This addendum (7 pages) shall form a part of and be included in the Contract Documents for the above titled project and no consideration will be entertained for extras to the Contract due to failure of the contractor to become thoroughly familiar with this addendum.

Project Title
PROVINCIAL FIRE AND LIFE
SAFETY PROJECT - ROBLIN,
RUSSELL, AND ROSSBURN
SITES.
ROBLIN HEALTH CENTRE
AND CROCUS COURT
PERSONAL CARE HOME
ROBLIN MANITOBA

Project Title
**PROVINCIAL FIRE AND LIFE
SAFETY PROJECT - ROBLIN,
RUSSELL, AND ROSSBURN
SITES.**
**ROSSBURN PERSONAL
CARE HOME AND HEALTH
CENTRE**
ROSSBURN MANITOBA

Drawing Title
ELECTRICAL SINGLE LINE
DIAGRAM - CROCUS COURT
AND ROBLIN HC - NEW
CONSTRUCTION

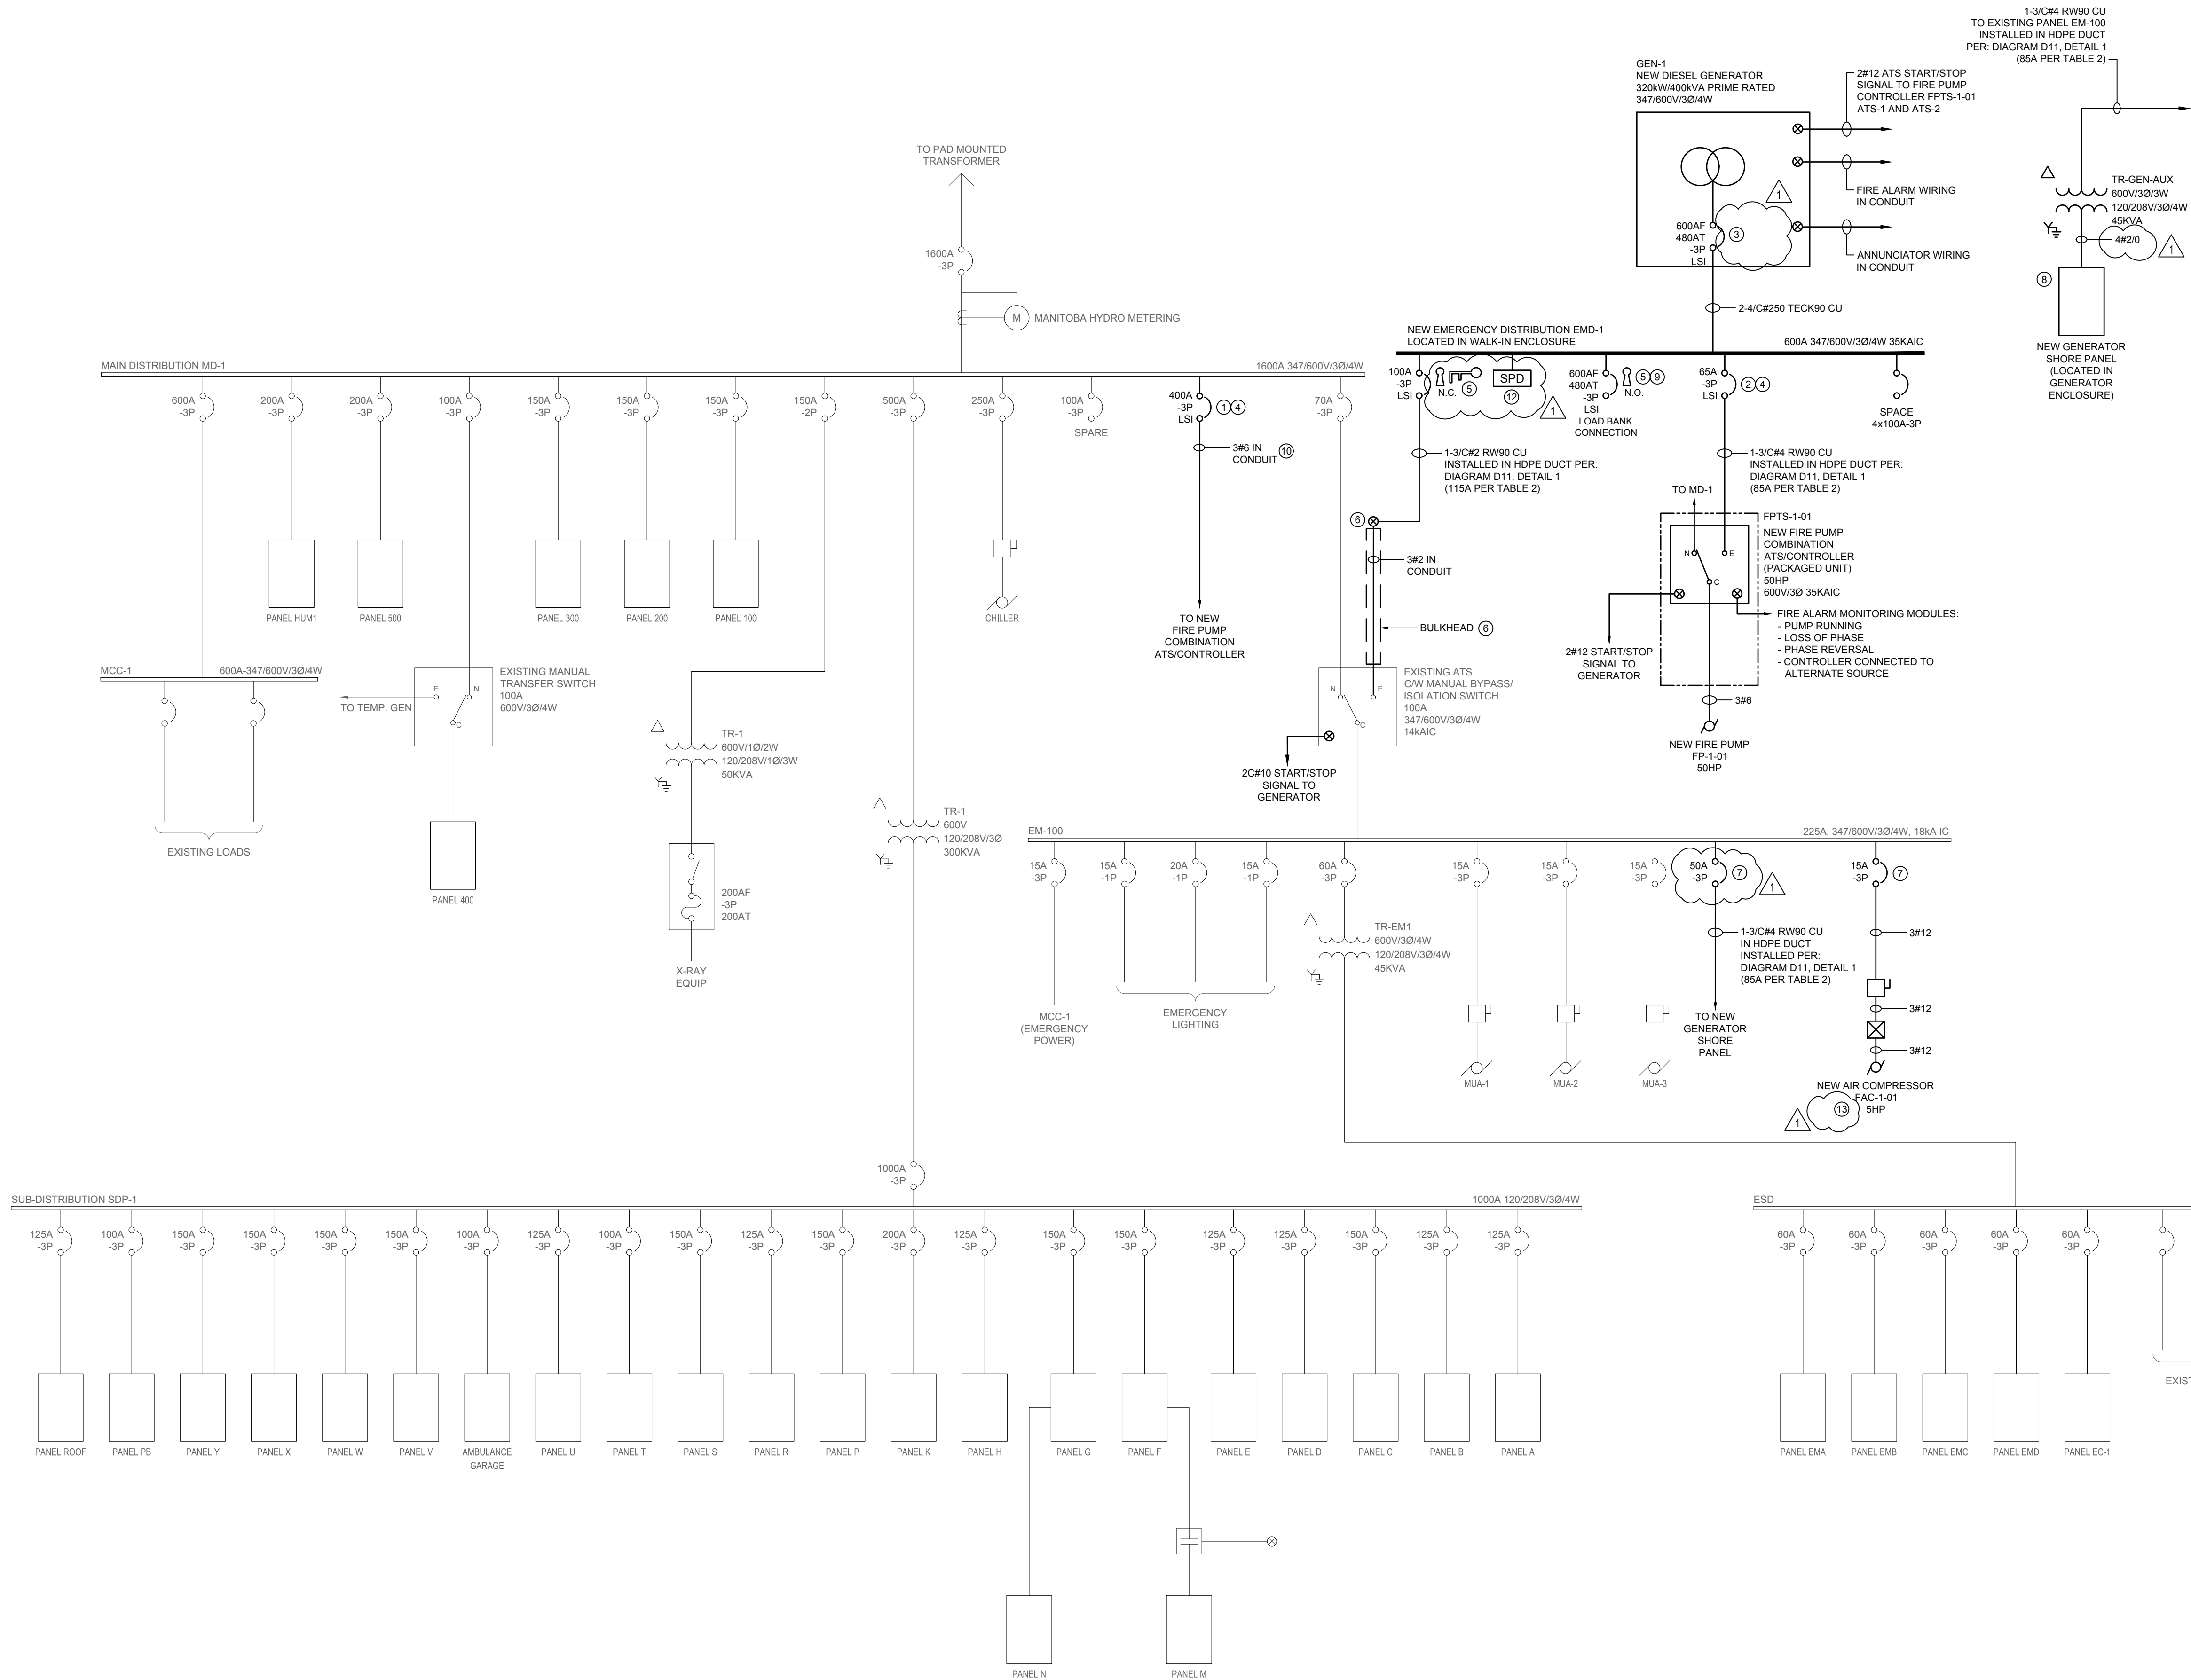
- .1 Refer to attached revised drawing for changes denoted by clouded area and triangle 1.
- .3 E2-221 ATTIC PLAN - RUSSELL HC, PART A- ELECTRICAL
 - .1 Remove key note reference bubble to Key Note #8.

Drawing Title
**ELECTRICAL SINGLE LINE
DIAGRAM - ROSSBURN
PCH AND HC - NEW
CONSTRUCTION**

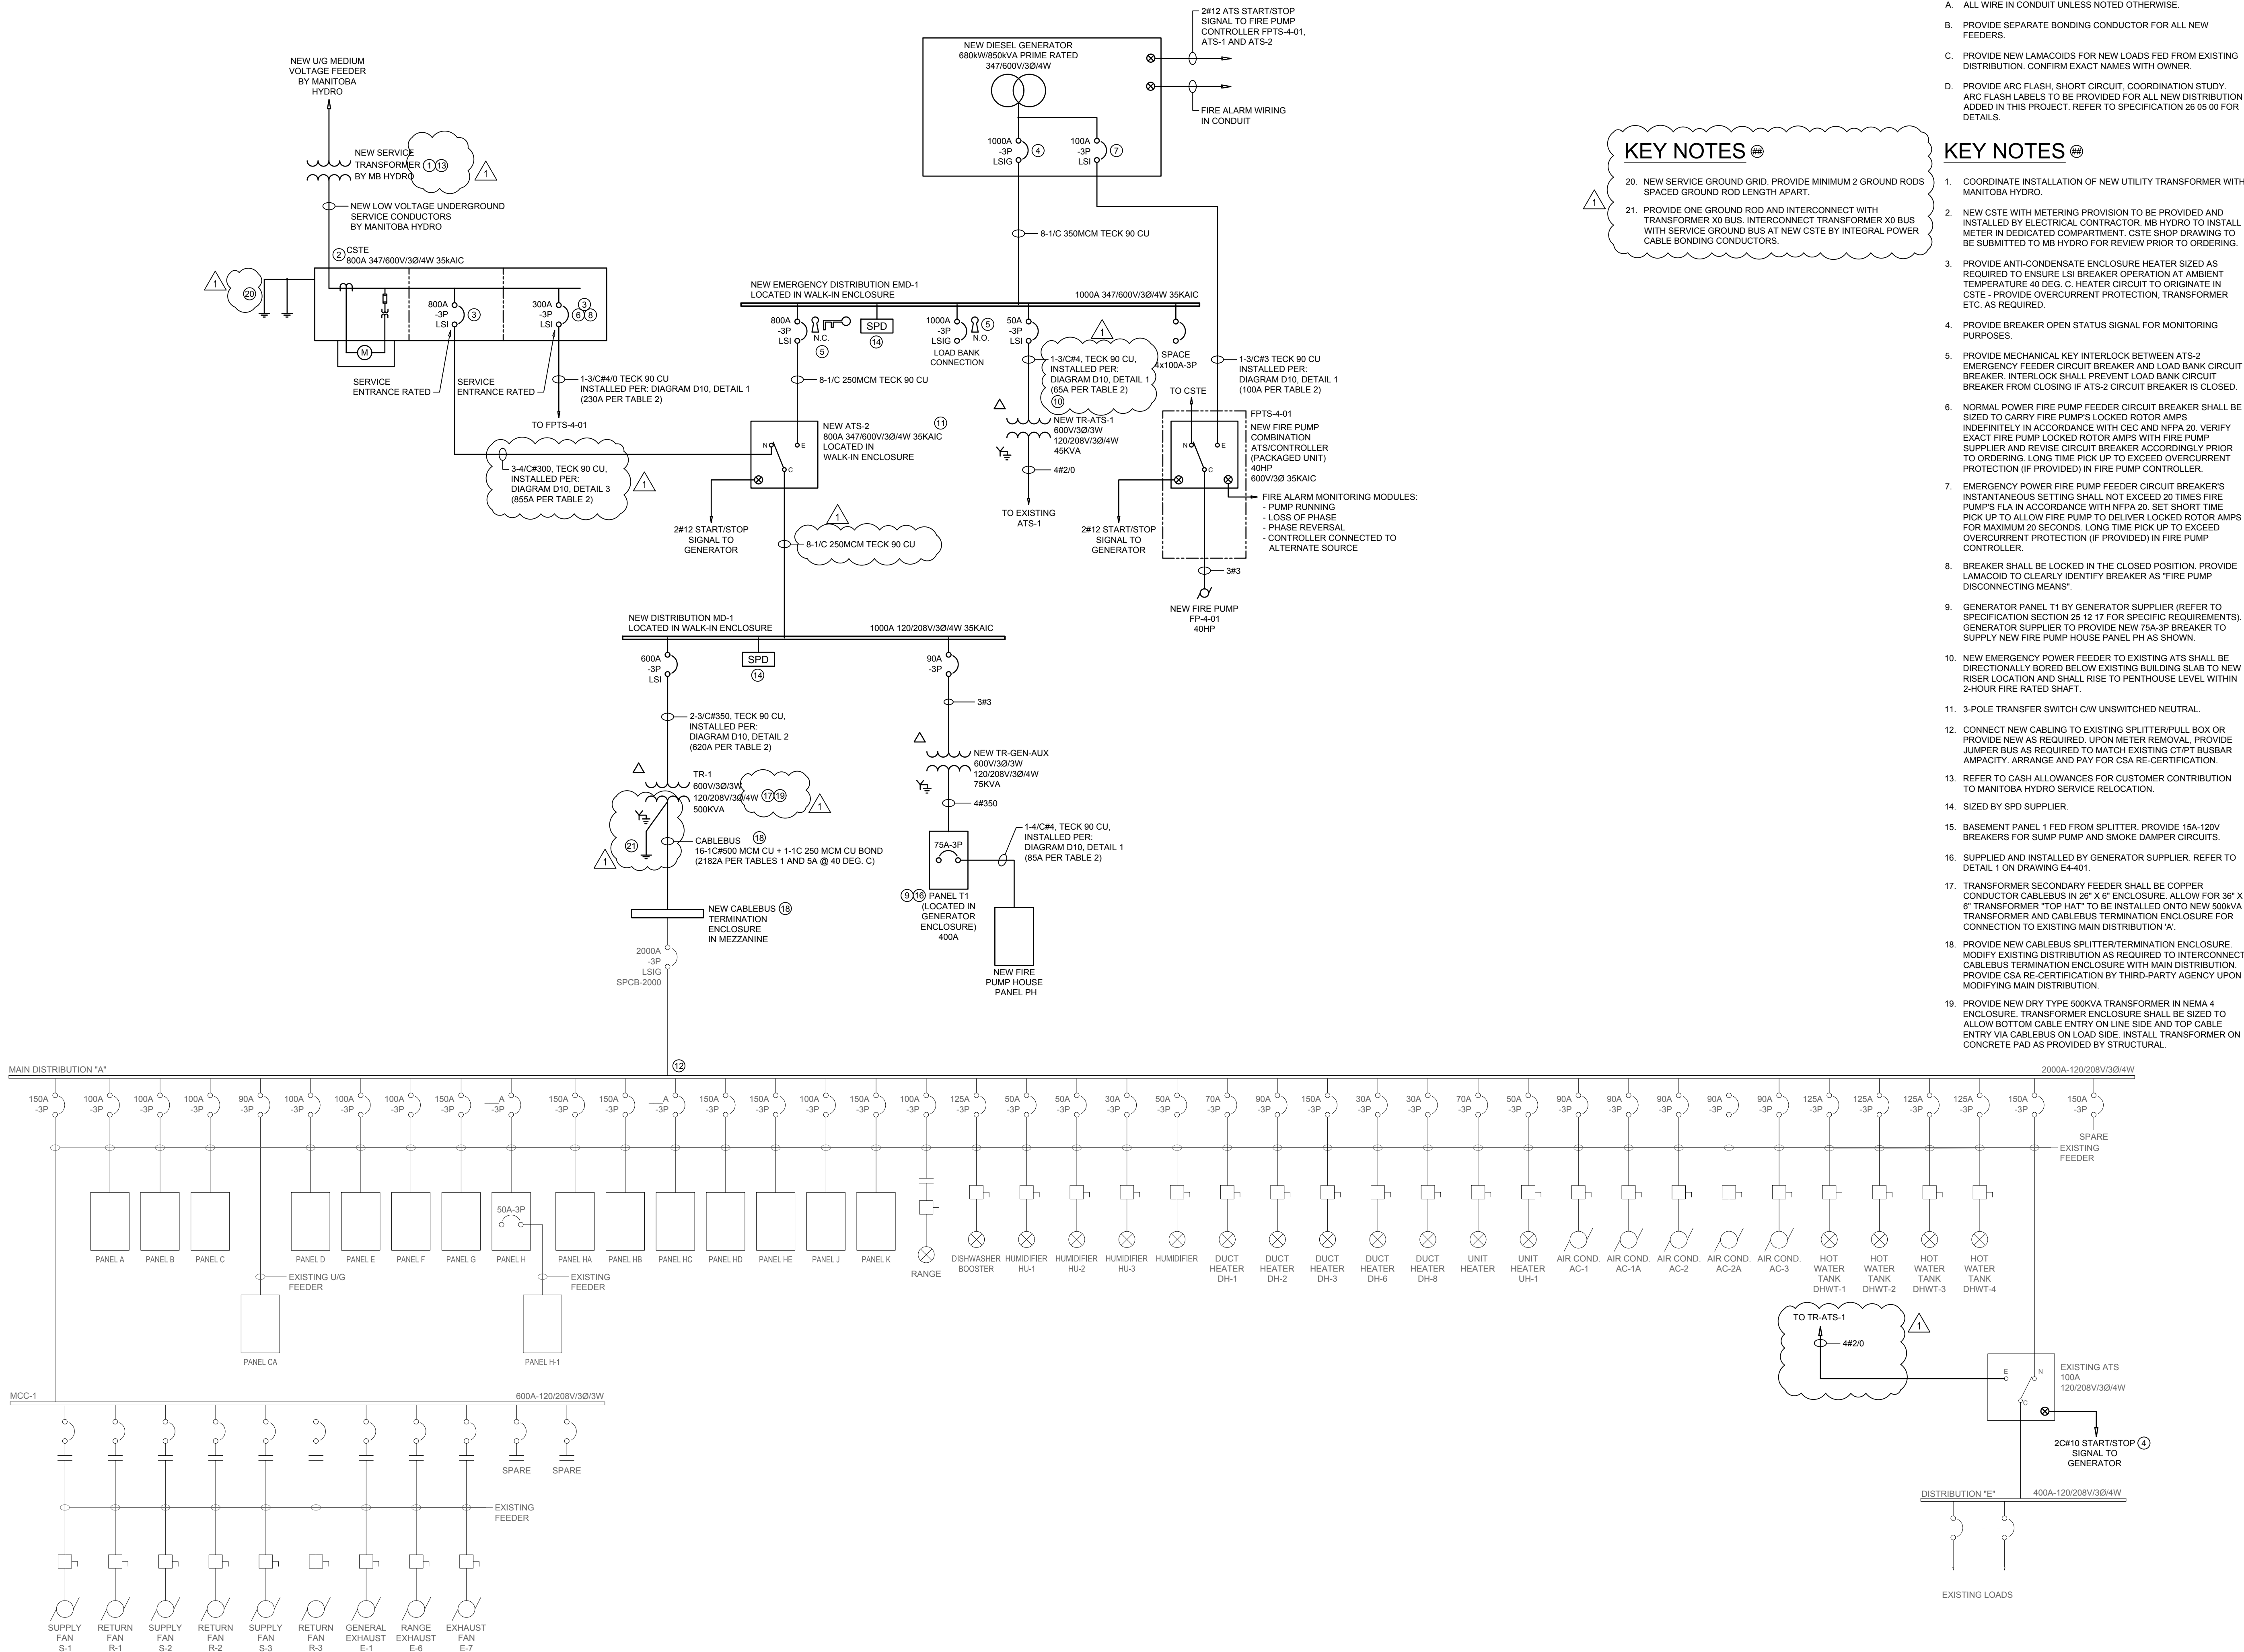
- .1 Refer to attached revised drawing for changes denoted by clouded area and triangle 1.

Drawing Title
MAIN FLOOR PLAN -
ROSSBURN HC, PART B -
ELECTRICAL

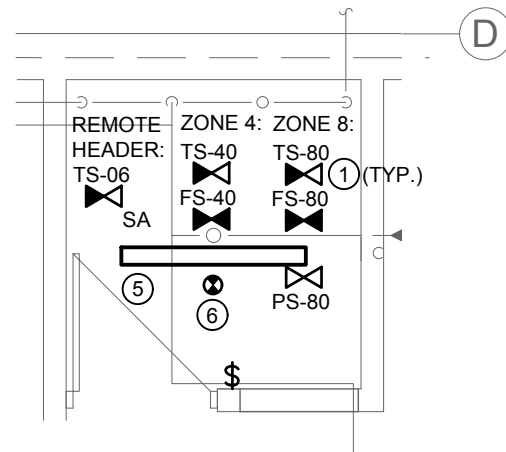
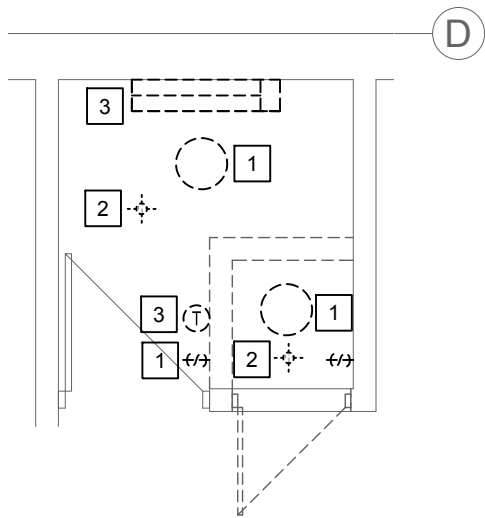
- .1 Refer to attached revised drawing for changes denoted by clouded area and triangle 1.
- .8 E4-302 ELECTRICAL SINGLE LINE DIAGRAM - ROSSBURN PCH AND HC - NEW CONSTRUCTION
